VSP - 149
DATE: December 16, 2002 (M)

SUBJECT: Distribution of: Kelly Aerospace Service Bulletin No. A-107A

SUBJECT: Inspection of Fuel Regulator Shutoff Valve as Used With Kelly Aerospace Combustion Heaters, Models B1500-B4500

Figure 1

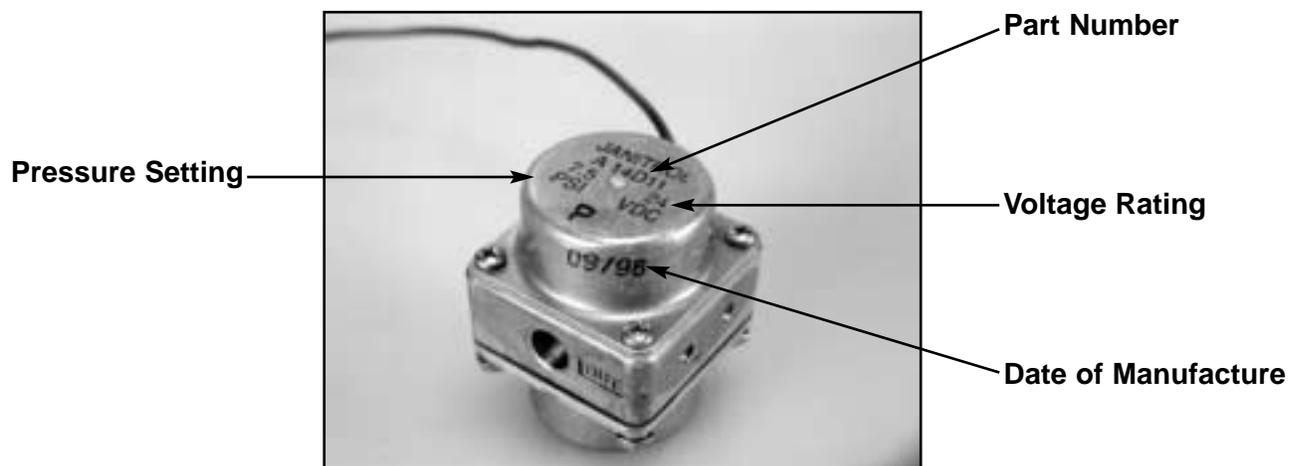
Kelly Aerospace part number 14D11 and 23D04 series fuel regulator and shutoff valves provide positive fuel shutoff and regulation of fuel inlet pressure to Kelly Aerospace model B1500-B4500 series combustion heaters as used on both piston powered and turbine powered business aircraft. These valves operate at inlet pressures of 4-50 psi depending upon installation and regulate fuel outlet pressure (inlet supply to the heater) to 1.0 psi, 7.5 psi, or 12 psi depending upon application. Each valve is identified with part number, pressure setting, voltage rating, and date of manufacture as shown in Figure 1.

Figure 2

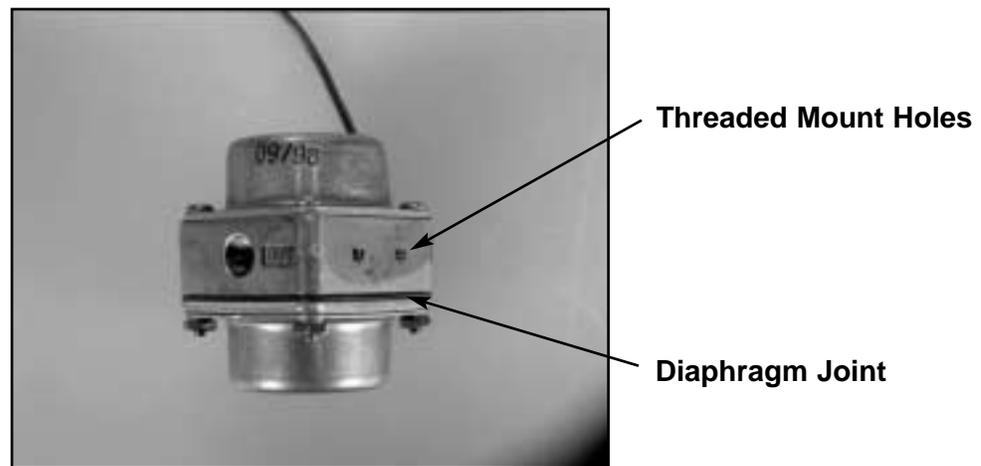
Recent field reports have indicated the possibility of fuel seepage at either the diaphragm joint or threaded mount holes as shown in Figure 2. Within the next 10 hours of operation, inspect the pressure regulator shut off valve for signs of fuel leakage as follows.

- b. Using mineral spirits or JET-A as the test fluid, pressurize the inlet port of the regulator valve to 50 psi for 1 minute minimum with the solenoid energized. Carefully inspect the valve body for signs of fuel leakage giving careful attention to the diaphragm joint and the threaded mount holes as shown in Figure 2. **CAUTION - prior to test, exercise care to wipe valve body and fittings free of any residual fluid that may have contacted external surfaces of the valve during test setup.** Leakage may appear as a wetness or seepage at the diaphragm joint or threaded mount holes. Rotate the valve during pressure test as necessary to fully inspect all external surfaces.

- 5) Visually inspect the valve body for signs of fuel stains, paying careful attention to the diaphragm joint and the threaded mounting holes located in sides of the valve body (see Figure 2). Fuel leakage in those applications using AVGAS may appear as a greenish blue stain or residue in the area of the diaphragm joint or threaded mount hole. Fuel leakage in those applications using JET-A fuel may appear as a wetness or oily residue at the diaphragm joint or threaded mount hole. Utilize supplemental lighting if needed to facilitate visual inspection. Visual inspection must include all four sides of the regulator valve body. If signs of fuel leakage are found replace the valve using a new valve of appropriate part number with a manufacture date code of 02/02 or later. Record valve replacement and Service Bulletin compliance in the logbook.

- c. If signs of fuel leakage are found replace the valve using a new valve of appropriate part number with a manufacture date code of 02/02 or later. Record valve replacement and Service Bulletin compliance in the logbook.
